ENGINEERING EVALUATION COVERSHEET

Number: EVAL-DE-2012-0316

Title: X-700 Roof Structural Integrity Assessment

FBP BUILDING ROOF ASSESSMENT

FINDINGS SHEET

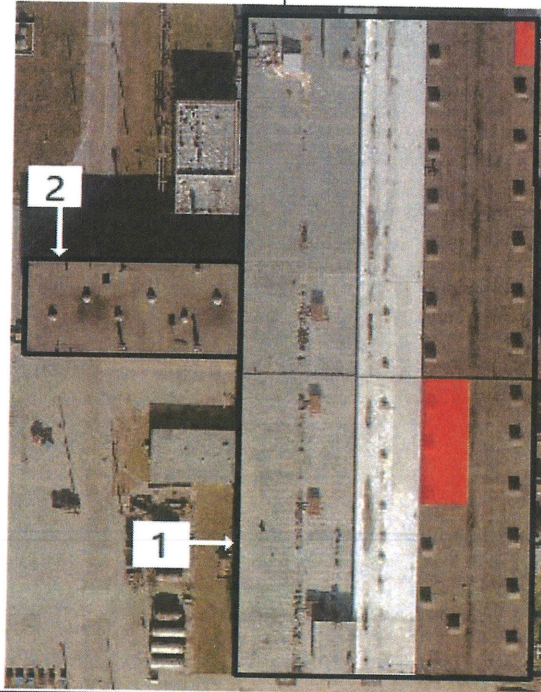
*NOTE: Access to the roof is restricted between columns E4/D4 through E7/D7 and F13/EF13 through F14/EF14.

The **X-700** roof is structurally adequate for Routine Maintenance Access to the areas identified above in the roof sketch for six employees (as defined on page 1 of this FBP Building Roof Assessment) on each of the two roof sections.

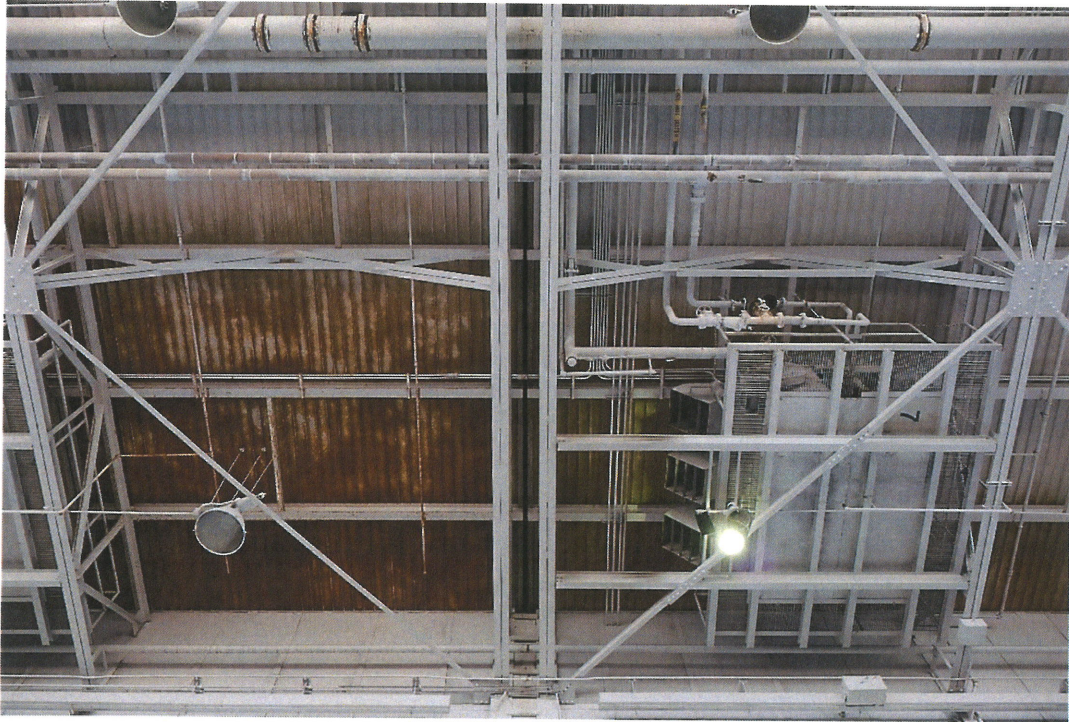
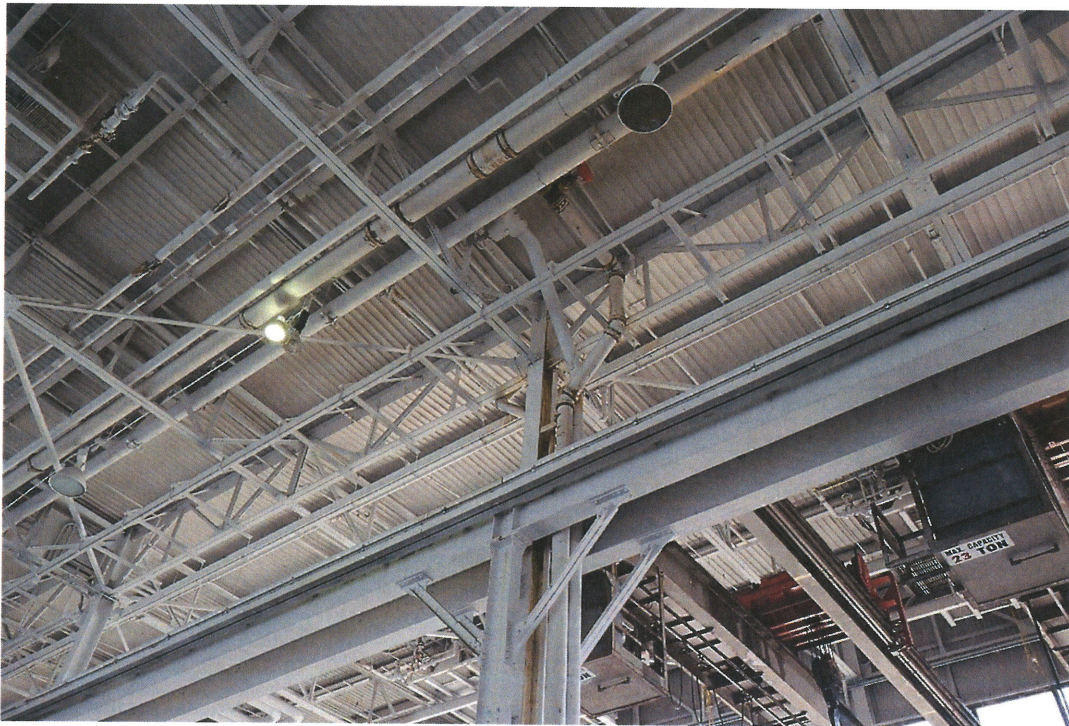
Corrosion between columns D4/D7 and E4/E7

Corrosion between columns D4/D7 and E4/E7

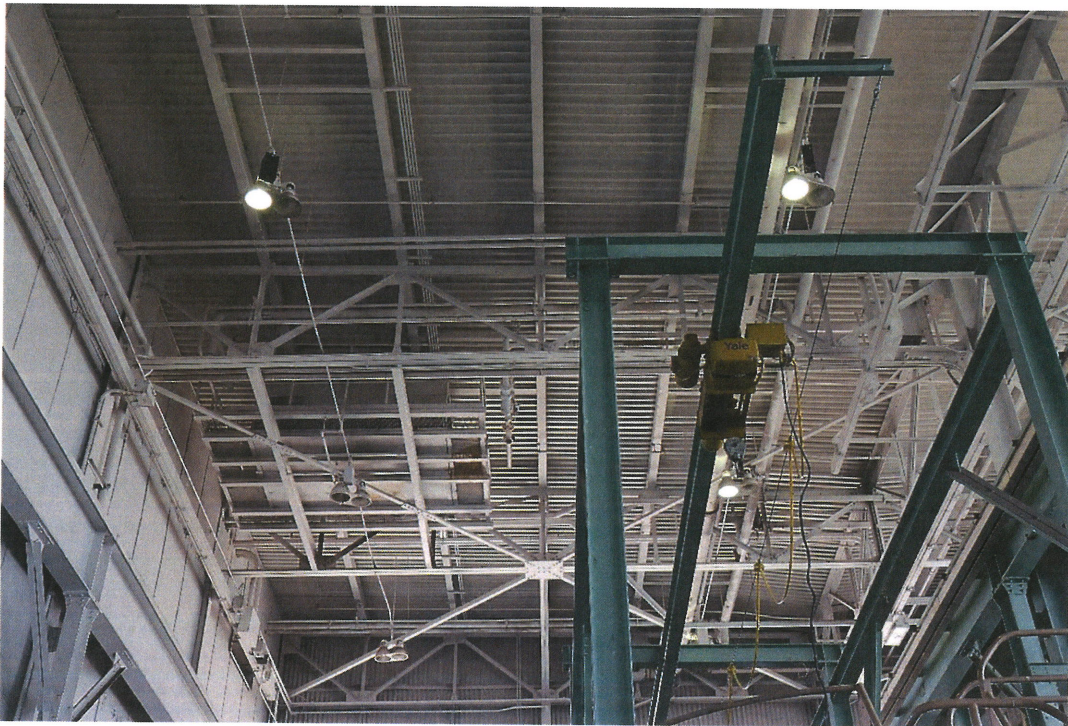
Corrosion on Northeast side of roof between columns EF13/EF14 and F13/F14

Close view of corrosion

Evidence of some sort of repair near column E12

X-700 Highbay Roof – East/South Section (FBP Area) (CONT.)

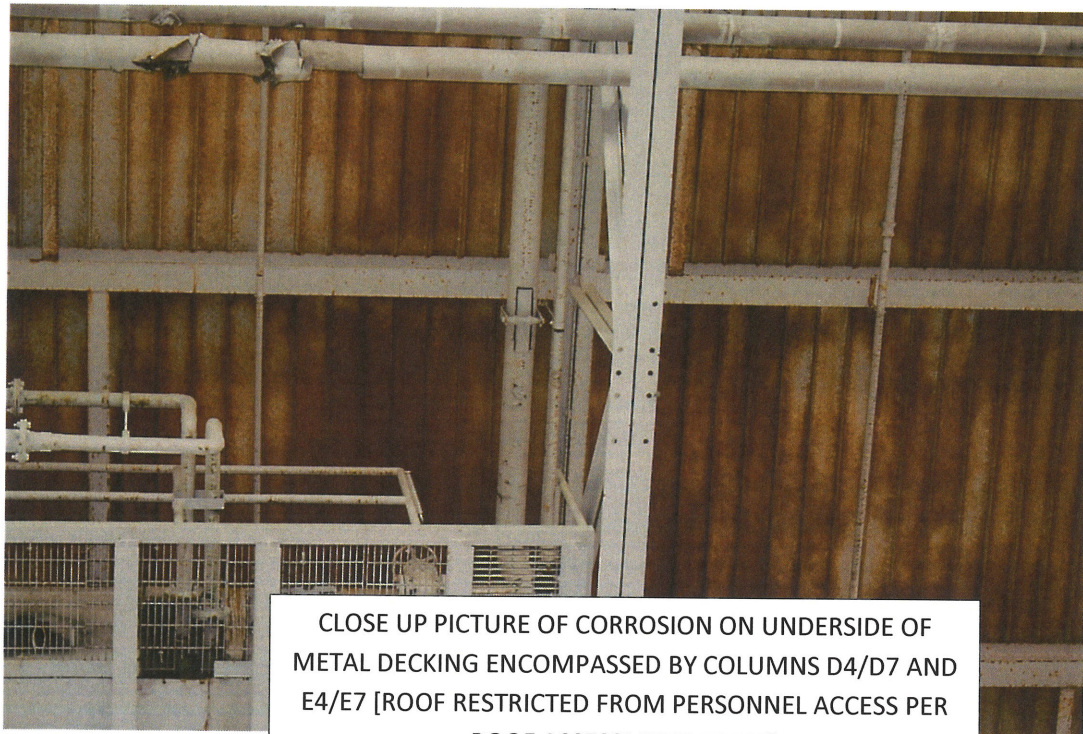
CORROSION DETECTED ON UNDERSIDE OF METAL DECKING ENCOMPASSED BY COLUMNS D4/D7 AND E4/E7 [ROOF RESTRICTED FROM PERSONNEL ACCESS PER ROOF ASSESSMENT FORM]

CLOSE UP PICTURE OF CORROSION ON UNDERSIDE OF METAL DECKING ENCOMPASSED BY COLUMNS D4/D7 AND E4/E7 [ROOF RESTRICTED FROM PERSONNEL ACCESS PER ROOF ASSESSMENT FORM]
